SUBJECT: Forwards addl clarification re 811210 proposed license
 amend re moderator temp coefficient, in response to NRC
 820125 request.

Re: Turkey Point Unit 3 & 4
Docket Nos. 50-250 and 50-251
Proposed License Amendment
Moderator Temperature Coefficient

COMPARISON OF RESULTS FOR THE
BANK WITHDRAWAL FROM SUBCRITICAL ANALYSIS
USING DIFFERENT MODELS

FIGURE 1: TURKEY POINT DANK WITHDRAWAL FROM SUBCRITICAL AVERAGE CHANNEL TRANSIENT

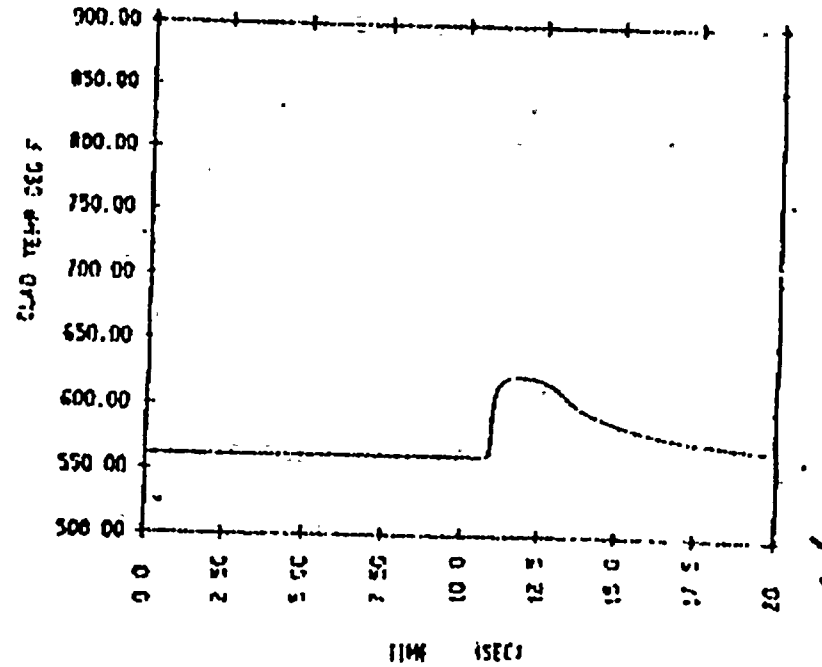
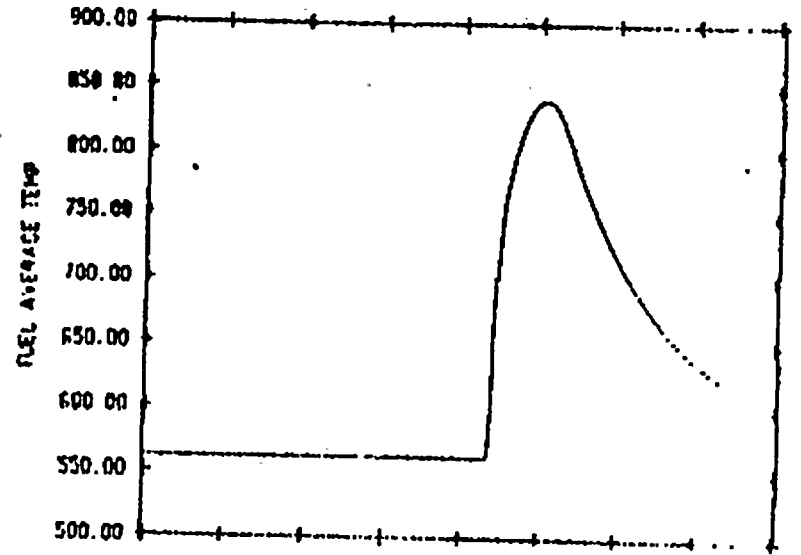
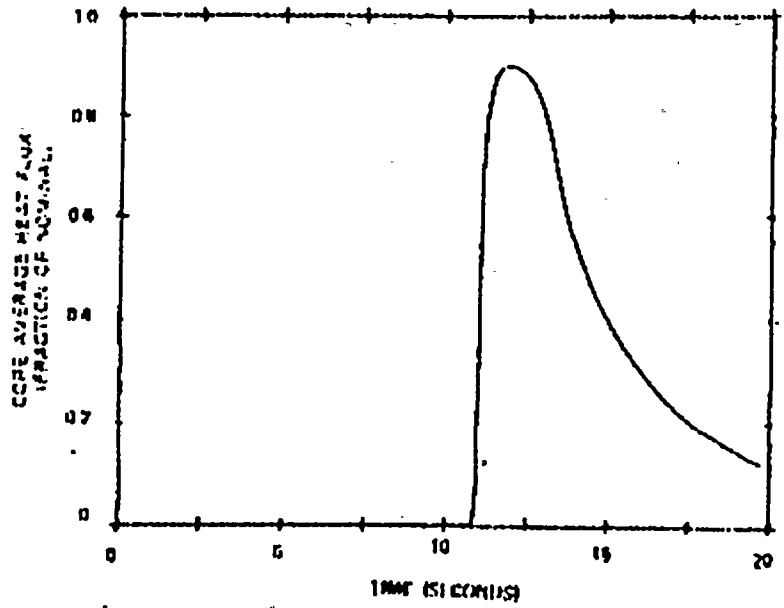
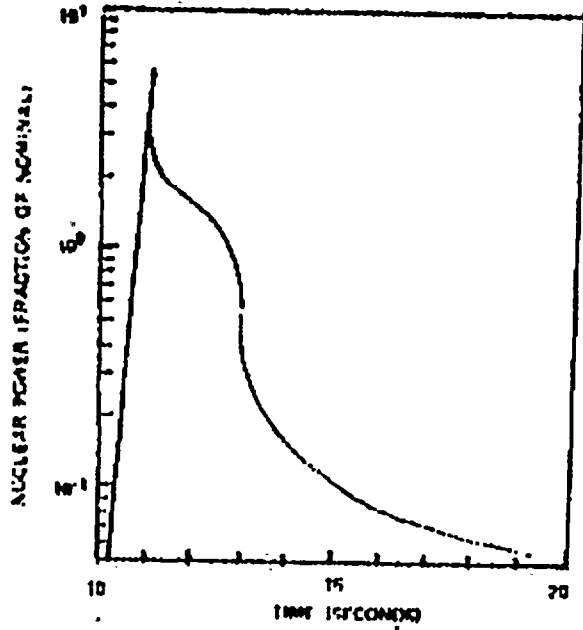
The conservatism inherent in the point kinetics model is easily seen by comparing the values in Table 1 and the transients in Figures 1 and 2. For the same reactivity insertion rate of 75 pcm/sec, the maximum nuclear power as calculated by MIT-6 is approximately six times the value calculated by THINKLE. The maximum average heat flux is more than twice the value calculated for Seabrook (.901 vs .339). The predicted fuel and clad temperatures are also higher in the Turkey Point analysis than in the other three calculations, indicating

In conclusion, the table and figures show that the point kinetics model is highly conservative since a comparable 1-D model analysis of the bank withdrawal from subcritical analysis yields acceptable results, i.e., DNBR above the limit value. Therefore, it can be concluded that the licensing basis of Turkey Point is sufficient to show that the minimum DNBR is greater than the limit value of 1.30.

FIGURE 2: SEABROOK BANK WITHDRAWAL FROM SUBCRITICAL
 AVERAGE CHANNEL TRANSIENT
 MINIMUM DNBR AT HOT SPOT = 1.59

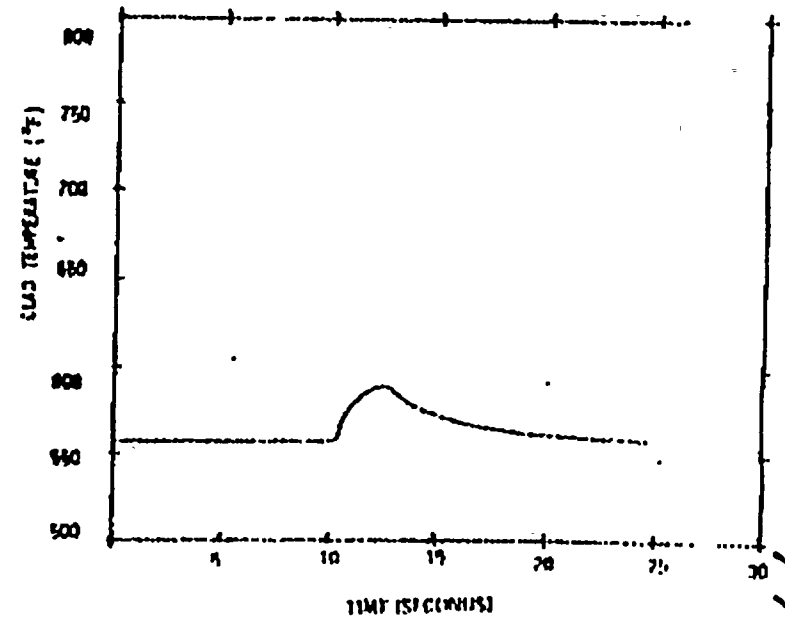
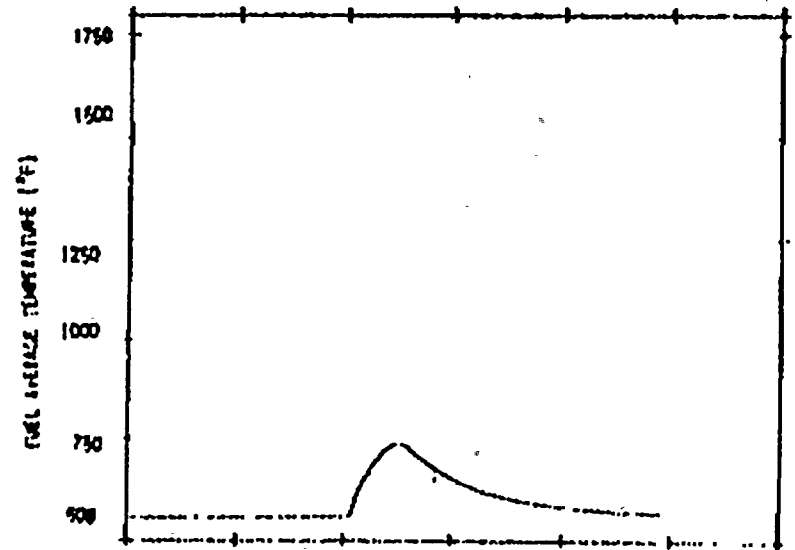
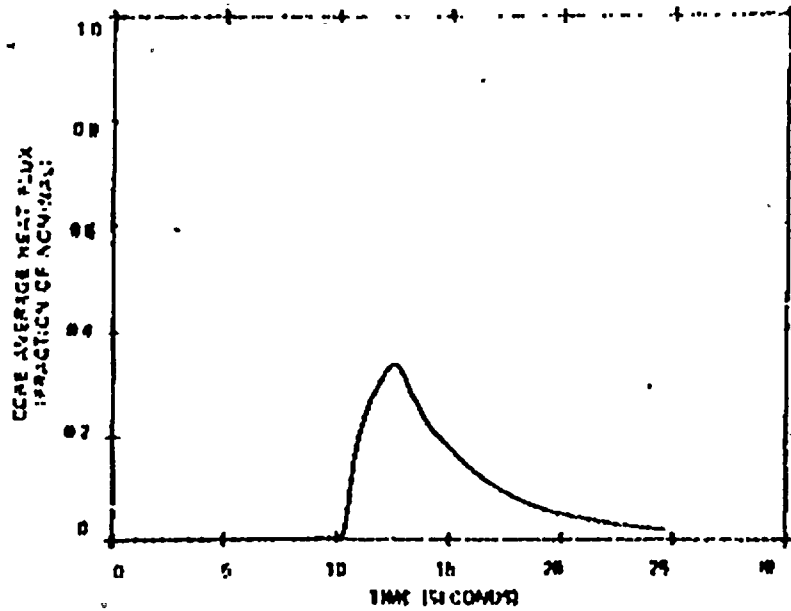
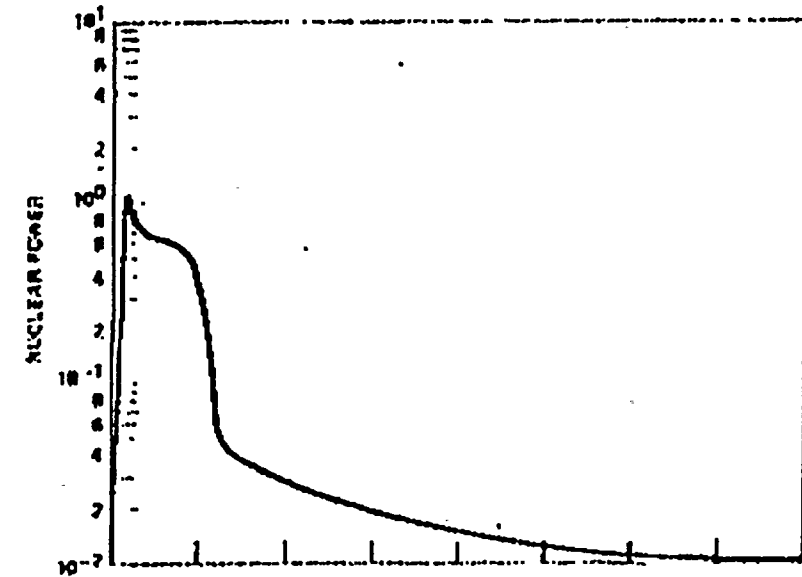
a conservatively low amount of subcooling. Thus, the Turkey Point analysis bounds the 1-D analysis for the average channel. The minimum DNBR's for all three plants presented remain above the limit values, for Seabrook, the minimum DNBR is 1.59. This is well above the limit value of 1.30.
